ACCESS PERMIT APPLICATION

Permit # QC 2022-0001
Parcel ID: 49112

Description of Project: FUTURE SINGLE FAMILY HOME Is property in floodplain? NO

Sketch Plan:

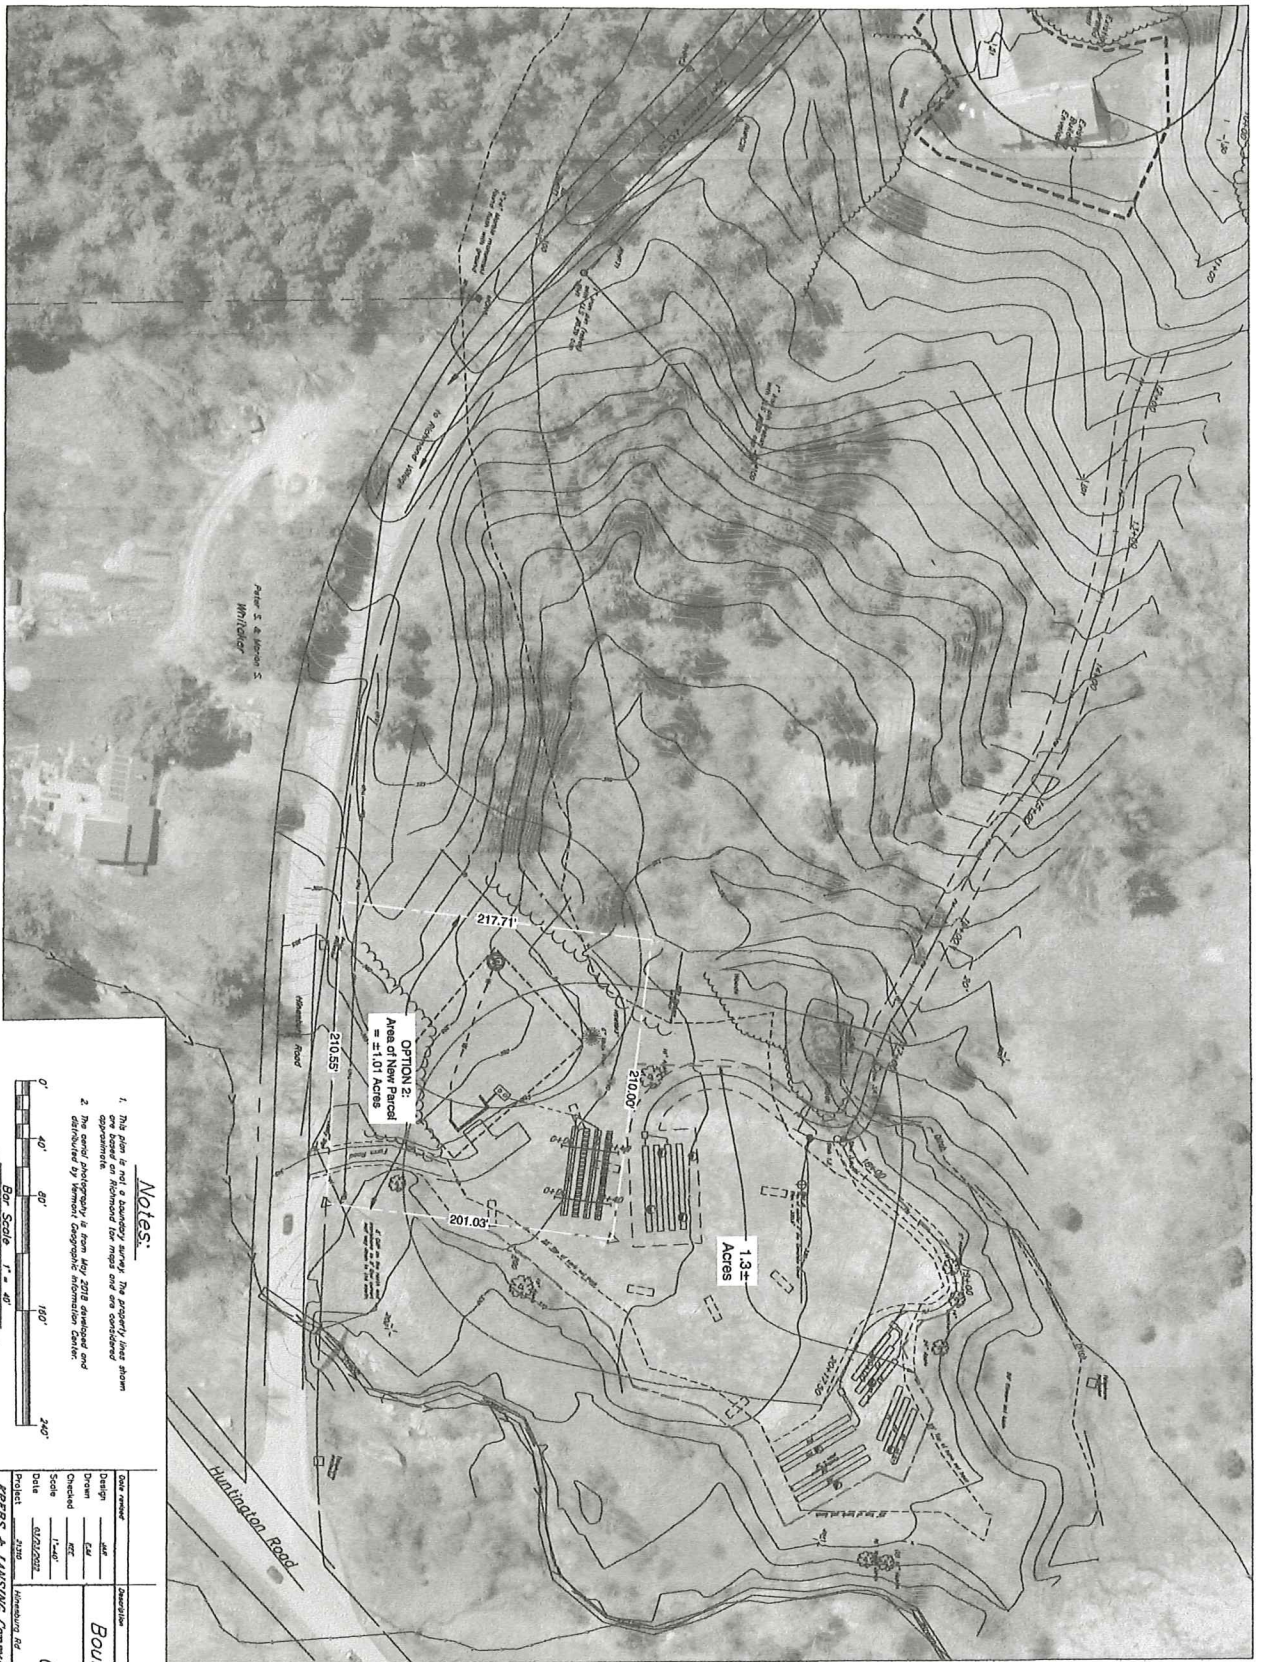
Highway Department Comments: INTERSECTION IS 290' OK. SIGHTLINE FROM ACCESS LOOKING WEST IS 470' OK. INSTALL 12" X 30' HOPE CULVERT AT LOW POINT IN ACCESS.
